Product Change Notification

Product Line:	5 pole A Series	Part No:	NC5F/MA*
Piece Part:		Part No:	
Engineering Change Request:		Date:	
Engineering Change Execution:		Date:	July 2012
Comments:	New connector design

Affected products:	<p>Changed versions: NC5FAH, NC5FAH-D, NC5FAH-0 NC5FAV, NC5FAV-D NC5MAH, NC5MAV</p> <p>Remaining versions: NC5FAV-SW, NC5FAV-SW-D, NC5MAV-SW</p>
--------------------	--

NC5MAV

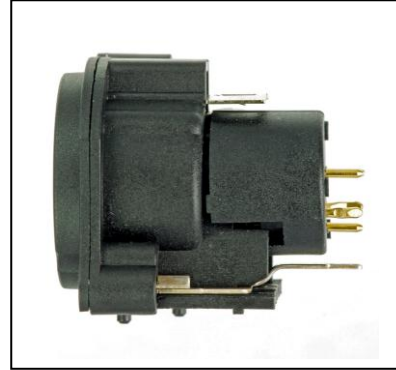
- **New housing design:**

Plastic housing optimized for best workability. Plastic material remain polyamide PA6.6 30%GR with flammability rating UL94HB.

- **New female contact design:**

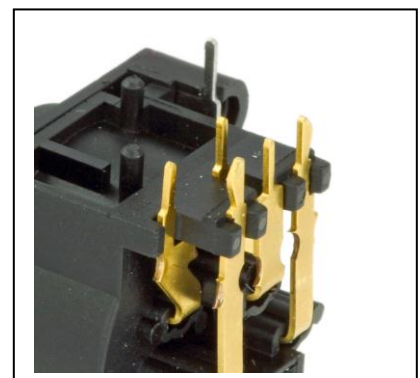
Contact design remain fork type. Plating adapted by selective gold plating of contact area and tin plated pcb termination area for best conductivity and solderability. Tear drop design and pcb footprint remains unchanged

Female

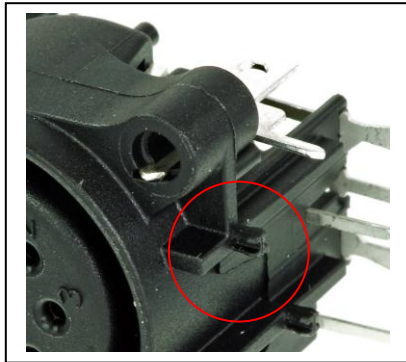
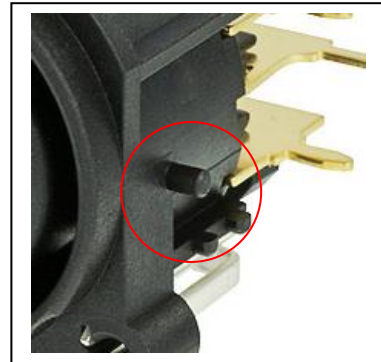
- **New location pin:**

The cylindrical pin shape is replaced by the press-fit design like on the A- and B-series. The pcb layout is not changed and remain the same. Existing pcb's can be further used.

- **Male locking element:**

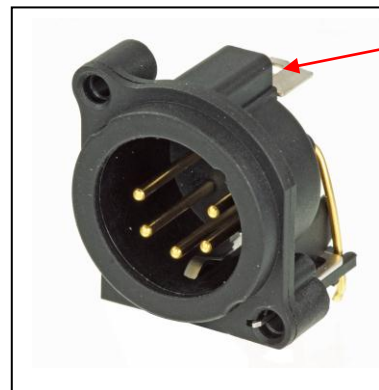
Locking element incorporated into the plastic housing instead of metal piece. Locking force greater than 200N.

replaced as described above

NC5FAV

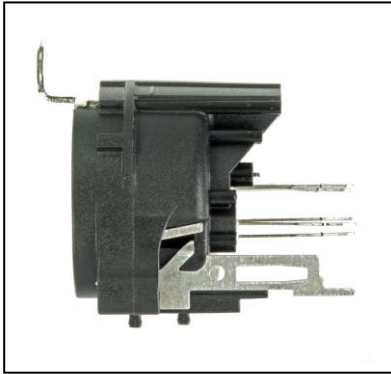
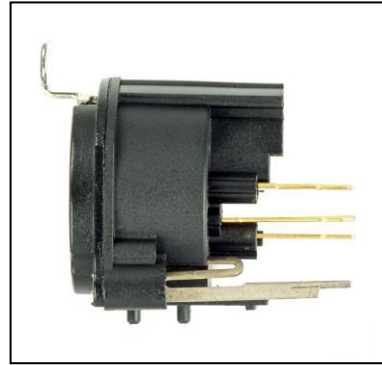
- **New female ground contact design:**

Ground contact design similar to the shape of ground #2 of A, B and A-combo series.
